TOYOTA TECHNICAL SERVICE BULLETIN

NO.: SU004-96

MODEL: TER, PAS, COR, CAM, AVL, CEL, PRV

CAMBER ADJUSTING BOLTS

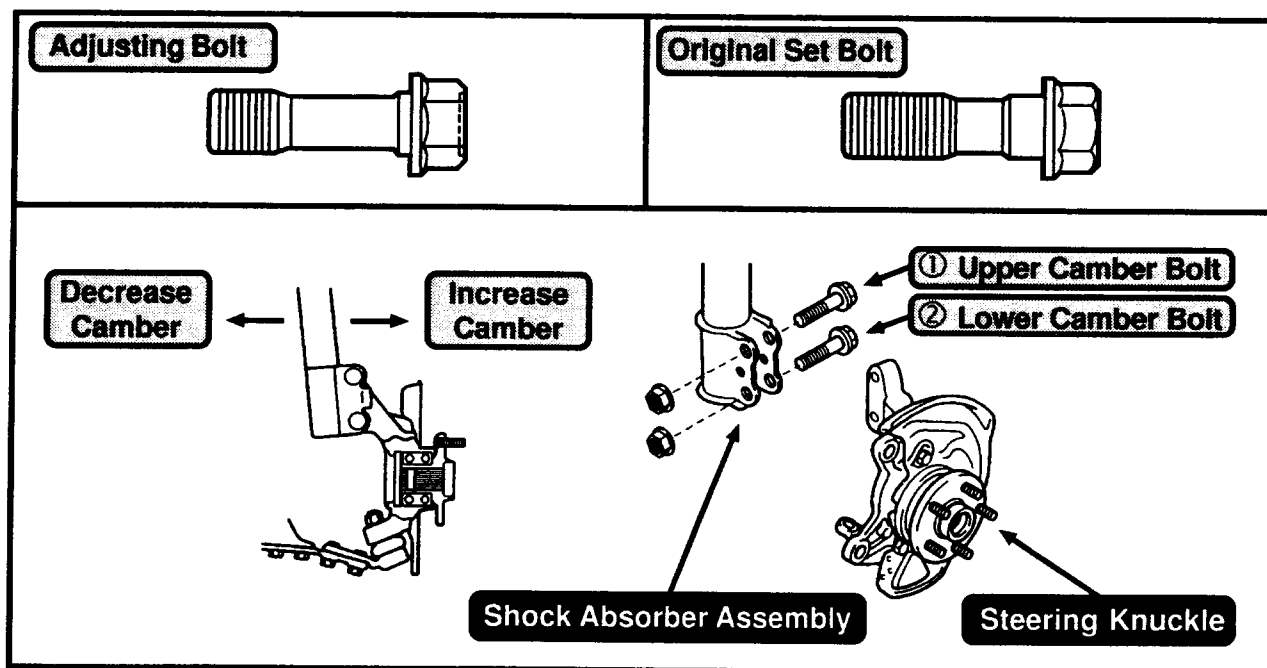
To increase camber adjusting capability, the steering knuckle set bolts can be replaced with new camber adjusting bolts. These new camber adjusting bolts allow for greater movement between the steering knuckle and shock absorber assembly.

To change camber, install the adjusting bolt in the lower steering knuckle mounting hole. If a camber change greater than 0.75° is required, camber bolts can be installed in both upper and lower steering knuckle holes for camber changes up to 1.50°. See Camber Adjusting Bolt Table on page 2 for model, part number and bolt selection.
